# Value Engineering Study

## Kentucky Transportation Cabinet

KY 15, Breathitt County Major Widening

Item No. 10-376.00

<b>CROSS SECTIONS: KY 15</b>	HORIZONTAL SCALE SCALE: 1" = 10'		STA 519+00 TO 519+50	ITEM NO. 10-376.00	COUNTY OF BREATHITT
					SHEET NO. X14

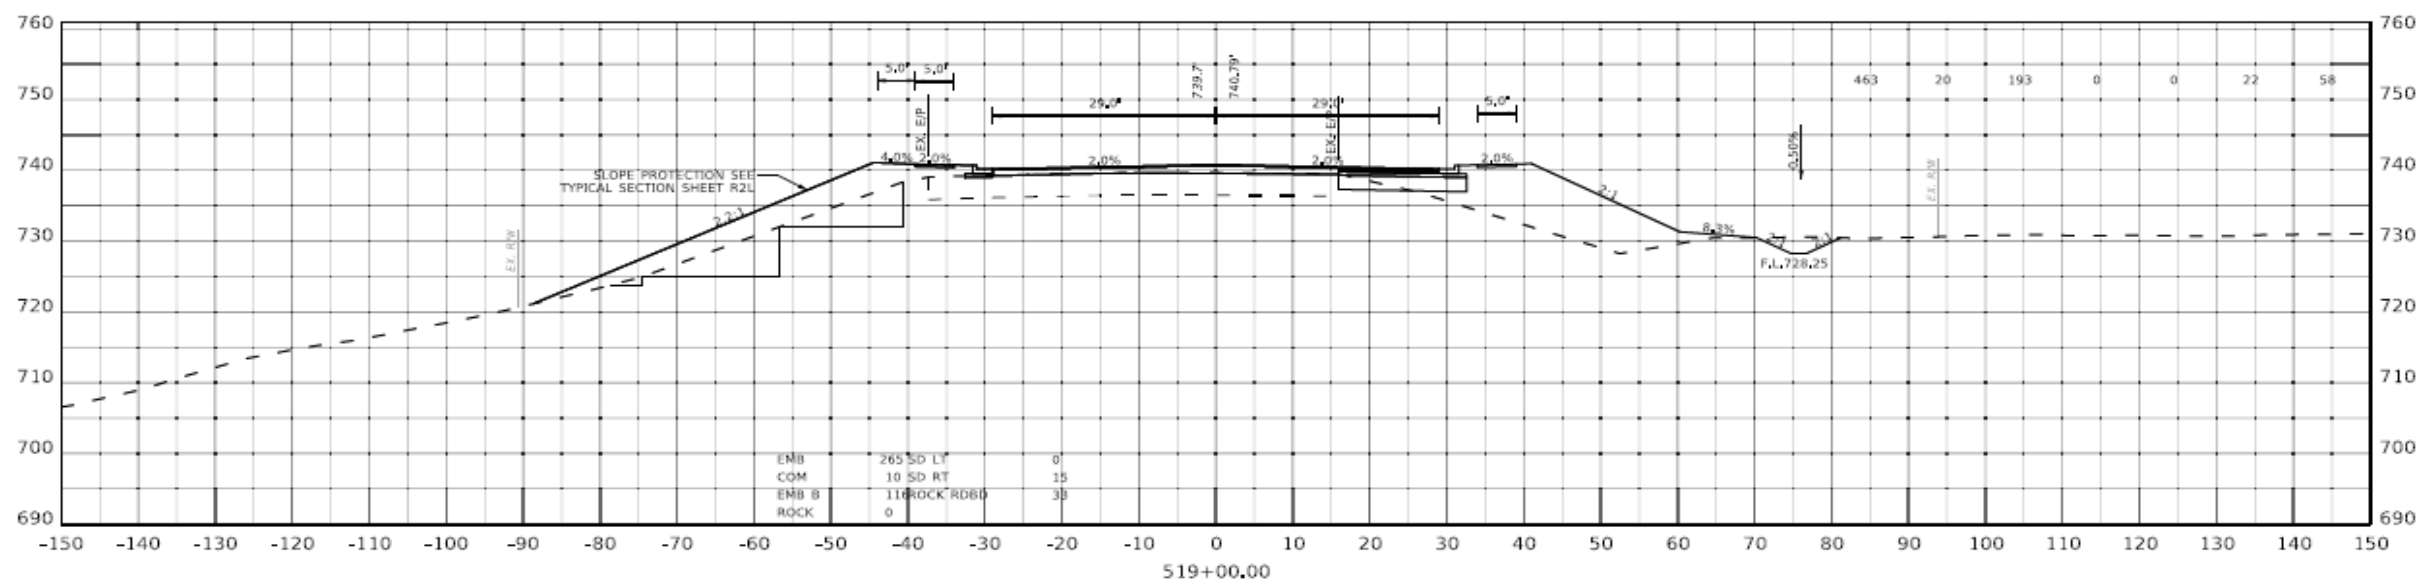
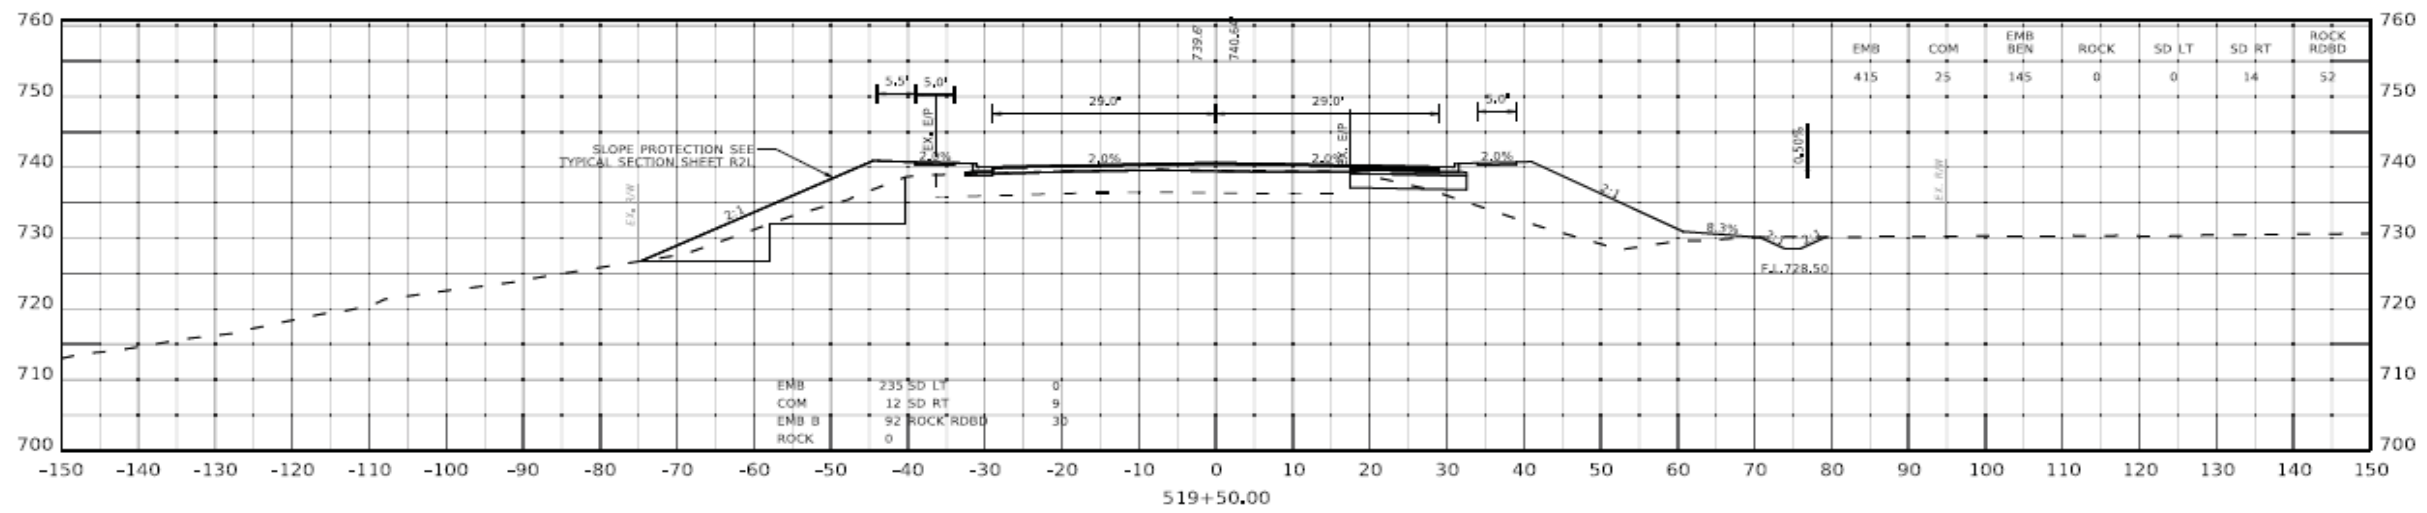
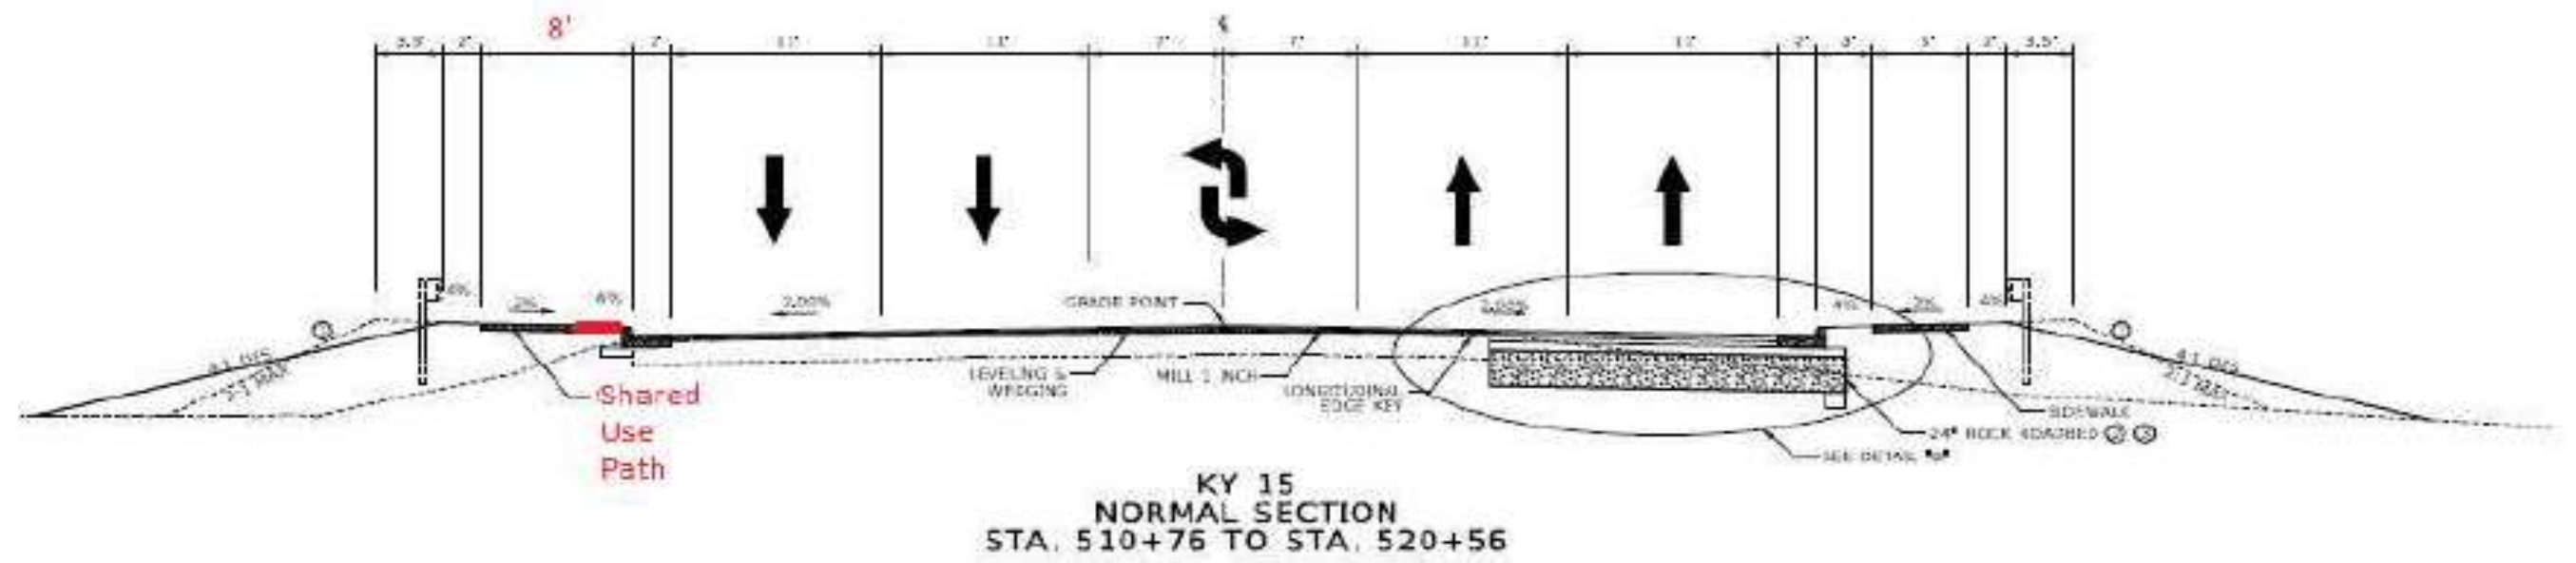
<b>TITLE</b>	Consider expanding shared use path up to Main Street		
<b>FUNCTION</b>	<b>Improve Non-Vehicular-Mobility</b>		
<b>VALUE PROPOSAL SYNOPSIS:</b>			
Change the sidewalk from Main Street to Jett Drive, about Lt. Sta. 511+50 to Lt. Sta. 520+40, to an 8' Shared Use Path using the 3' utility strip between the curb and sidewalk as was done on the current proposed Shared Use Path. This would allow bicyclist as well as pedestrians to have connectivity with the restaurants, Walgreens, gas station, etc., at the beginning of the project.			
 <b>Reliability</b>	Improved	 <b>Functionality</b>	Improved
 <b>O&amp;M</b>	Degraded	 <b>Schedule Impact</b>	Maintained
			<b>\$ Initial Cost Avoidance (Add)</b>
			<b>(\$16,000)</b>
<b>BASELINE CONCEPT:</b>			
Main Street to Jett Drive, about Lt. Sta. 511+50 to Lt. Sta. 520+40 has proposed a 5' wide sidewalk.			
<b>VALUE PROPOSAL:</b>			
Connect the proposed 8' Shared Use Path that ends at Jett Drive to Main Street by widening the proposed 5' sidewalk. Increase the width of the proposed 5' sidewalk to an 8' Shared Use Path. This provides a more protected/defined travel mode for bicyclist, keeping them from either riding on the current proposed sidewalk, or in the roadway. This will help to accommodate the 48% of households with zero to one car.

<b>TITLE</b>	Consider expanding shared use path up to Main Street
<b>DISCUSSION &amp; JUSTIFICATION:</b>	
<ul style="list-style-type: none"><li>• <b>Technical Considerations:</b> Change about 890' of the sidewalk from Main Street to Jett Drive, about Lt. Sta. 511+50 to Lt. Sta. 520+40, to an 8' Shared Use Path using the 3' utility strip between the curb and sidewalk as was done on the current proposed Shared Use Path. This would allow bicyclist as well as pedestrians to have connectivity with the restaurants, Walgreens, gas station, etc., at the beginning of the project. Follow the design of the current Shared Use Path where the additional 3' comes from using the 3' utility strip, this recommendation also would use the current proposed 3' utility strip</li><li>• <b>Cost Considerations:</b> There will be some additional cost.</li><li>• <b>Schedule Impacts / Project Management Considerations:</b> This change should be rather simple and would mostly likely be completed in a less than a week by remodeling the Shared Use Path, editing the typical sections as shown on the attached sketch, and editing the cross sections as shown on the attached sketch.</li><li>• <b>Risk Considerations:</b> Adding this Shared Use Path removes risk associated with the reality of putting bicyclist either into the roadway or riding on the sidewalk with pedestrians, which is not supposed to be done.</li><li>• <b>Stakeholder Acceptance:</b> This additional path will help to fully accommodate the area to the best the project can provide for non-motorized users meeting the Purpose and Need.</li><li>• <b>Implementation Considerations:</b> Might be advisable to share with the utility companies so that they know the utility strip will have the Shared Use Path on it.</li></ul>

COUNTY OF  
BREATHITT  
DRAWING NUMBER  
28745

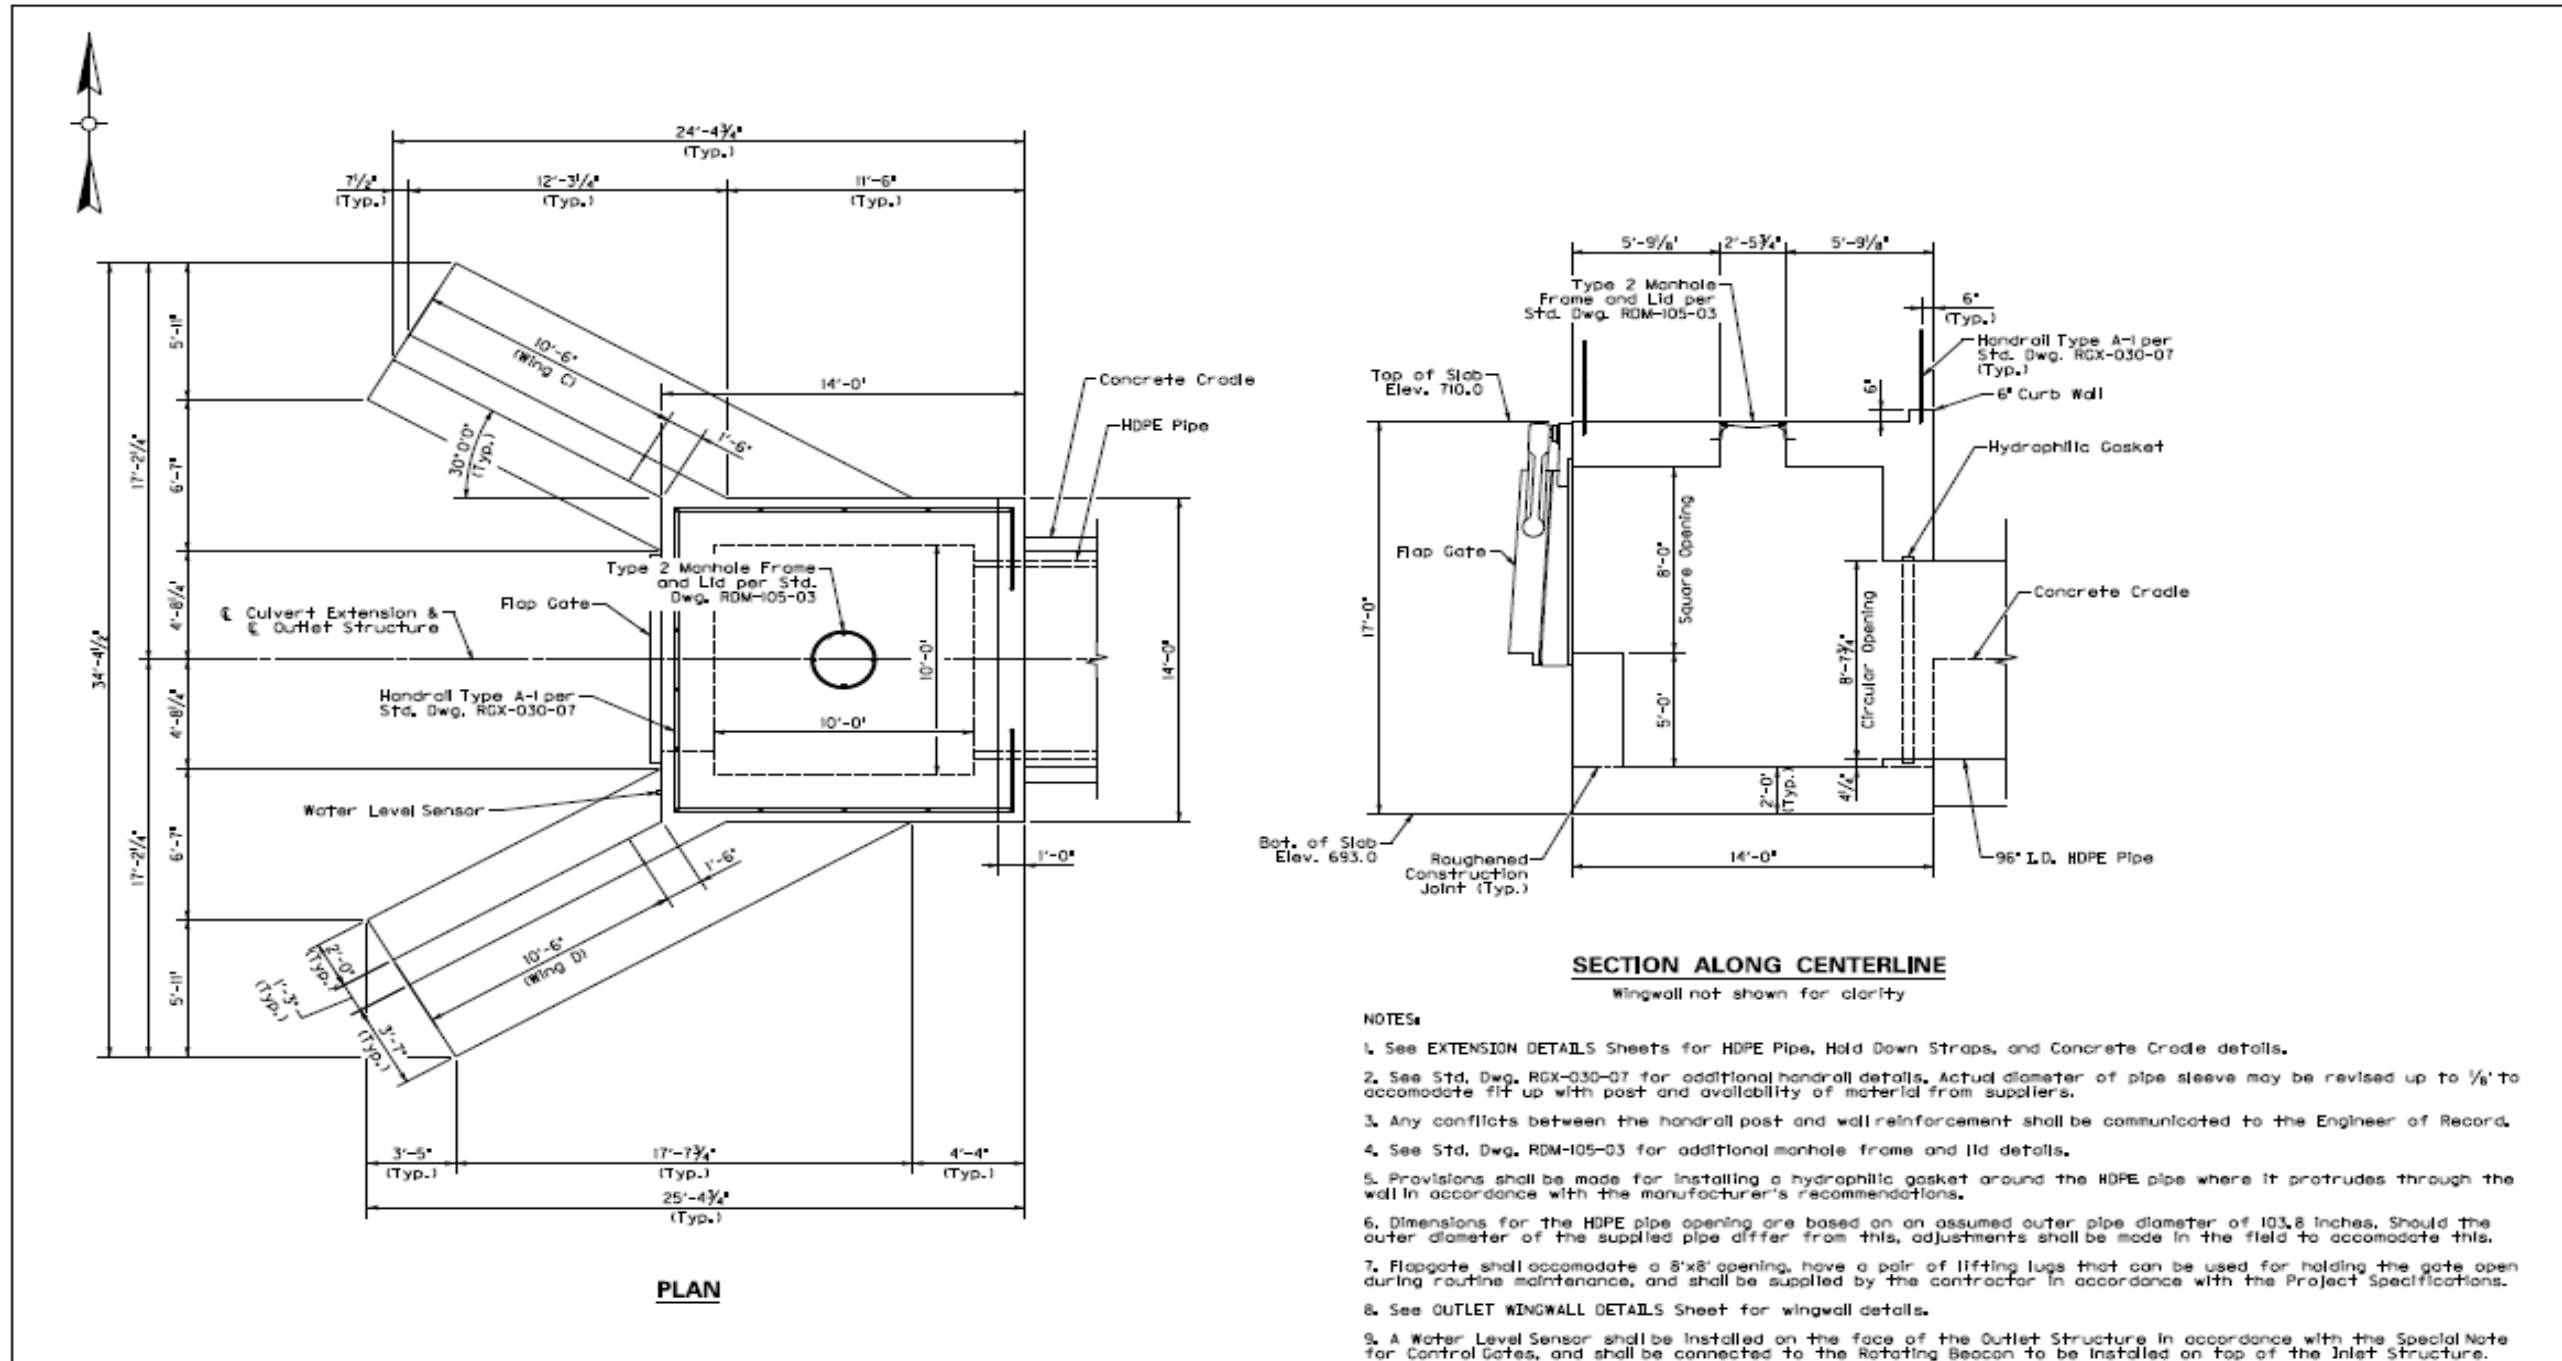
Idea No.	Idea Title
CS-02	The reinforcement on the northwest wall opening on Drawing No. 28745 is less than required by ACI 318-19 8.5.4. LRFD does not cover this detail well
CS-04	Add an access ladder inside the inlet structure at Washington Avenue for maintenance access
CS-05	Consider standby pumps during construction; modify MOT note to include this language
CS-06	Give the Contractor the ability to shutdown Washington Avenue for flooding events during construction of culvert structures
CS-07	Add a backup system to open the gate in the event of mechanical failure
MT-05	Include in specifications language to allow for Washington Avenue closures during flooding event
OT-04	Steepen Lakeside Drive to decrease fill in the Panbowl area
MC-01	Review construction schedule <span style="color: red;">NOTE: The VE team reviewed the project schedule that was provided in the Grant. There was not sufficient detail to perform a thorough review. It is further noted that the Contractor will be providing a construction schedule for KYTC review.</span>

**NOTE:**  
 For HDPE Pipe and Concrete Grade details, see Drawing Number 28745.  
 For SECTION A-A, SECTION B-B, SECTION C-C & SECTION D-D, see OUTLET DETAILS (3 OF 3) sheet.

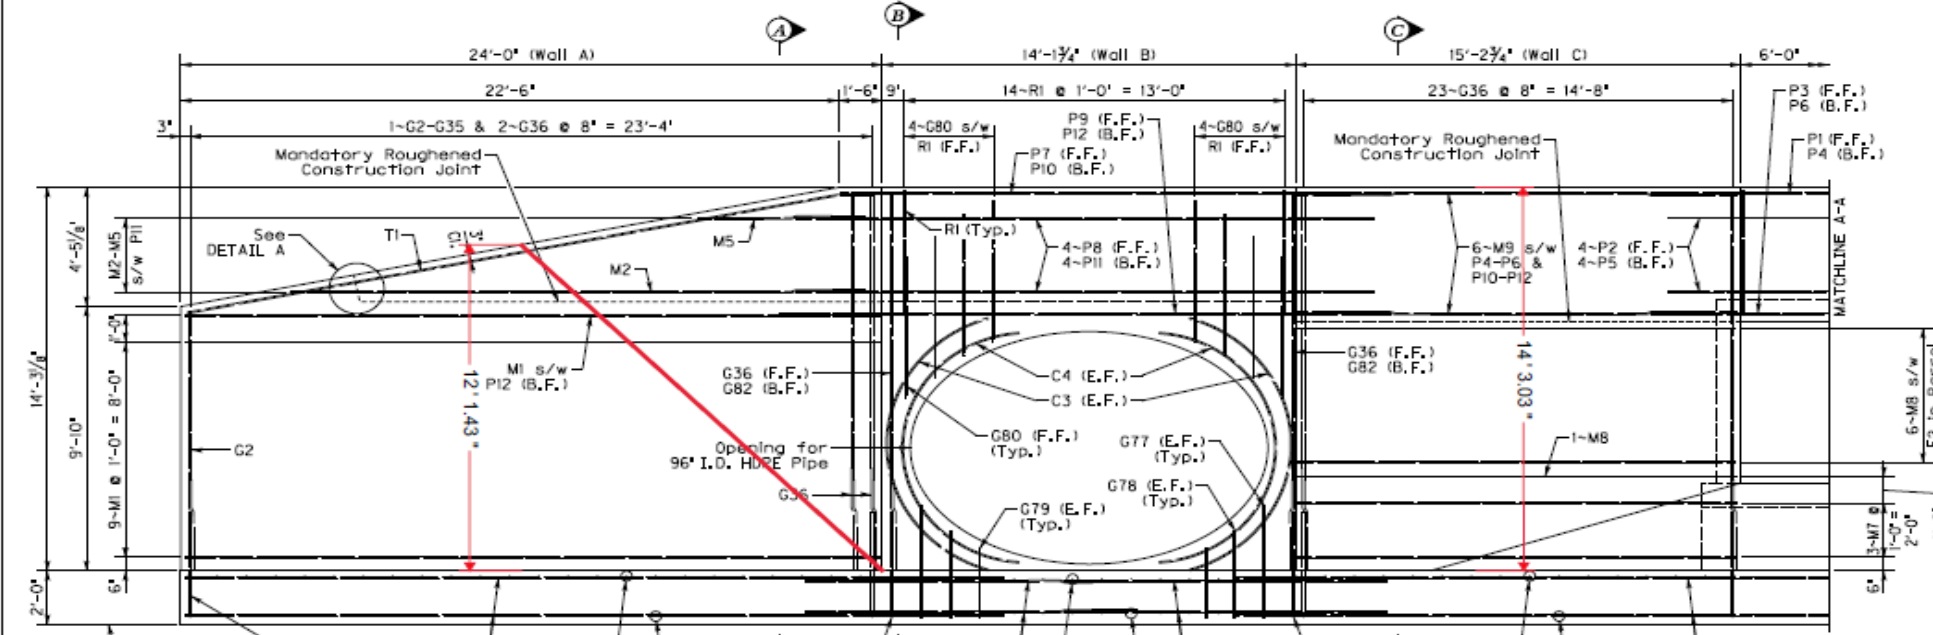
Wing wall design height is about 12'-1". Rule of thumb for retaining wall thickness is Height/12. This would be a 12" thick wing.
